LLOG and Seadrill – OMB/OIRA – (RIN) 1014–AA11

Seadrill's concerns with BSEE's proposed rule -2015-0002

Oil and Gas Sulphur Operations in the Outer Continental Shelf- Blowout Preventer and Well Control

Shear Ram – Timing Circuit Replacements

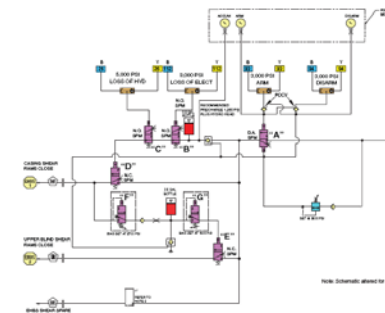
- Each emergency function must **close at a minimum, two shear rams in sequence** and be capable of performing their expected shearing and sealing action under MASP conditions as defined for the operation.

RISKS- Activation of **both blind** shear rams **during an unplanned event** such as a deadman activation in which an unshearable drill collar is across both shear rams would **damage both rams** disallowing the ROV activation of one after the well bore had been cleared to safely seal the well **therefore prolonging containment**. The solution is a risk based approach to shear ram activation modes based on total systems capability.

- A minimum of two sets of shear rams for shearing the drill pipe and tubing in use, of which at least one shall be capable of sealing for DP rigs.
- EDS sequence specific to rig operation. Deadman/Autoshear systems required.
- Autoshear/Deadman systems required to be armed unless risk assessed and managed by operating procedures.
